PREPARED FOR THE PLAN COMMISSION

Project Address: 223 South Pinckney Street (District 4- Ald. Verveer)
Application Type: Demolition Permit, Planned Development Alteration, Conditional Use, and Certified Survey Map
Legistar File ID # [55916](#), [55921](#), [56121](#), & [56288](#)
Prepared By: Kevin Firchow, AICP, Planning Division
Report includes comments from other City agencies, as noted
Reviewed By: Heather Stouder, AICP, Planning Division Director

Above: West Wilson Street - Lower Levels of Hotel
March 22, 2017 Plans

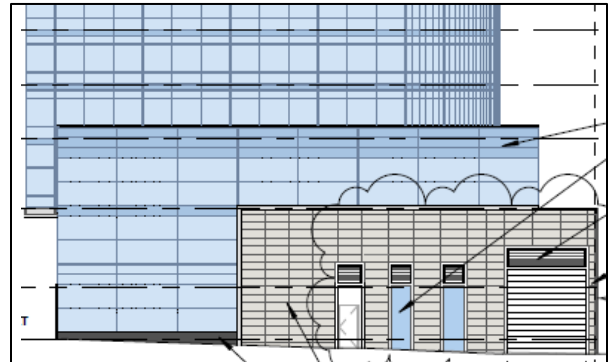
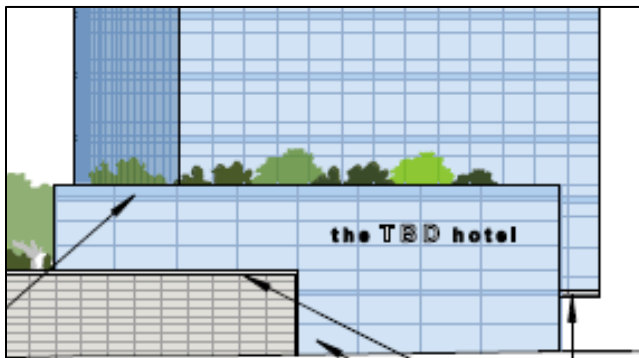
Corresponding façade changes are proposed to the East Wilson and Doty Street facades. Along Wilson Street, the previously approved underground parking entrance is now comprised of a door and spandrel-clad panels. Along Doty Street, additional windows and doors to an enclosed bike parking area are now proposed. No changes are proposed along South Pinckney Street.
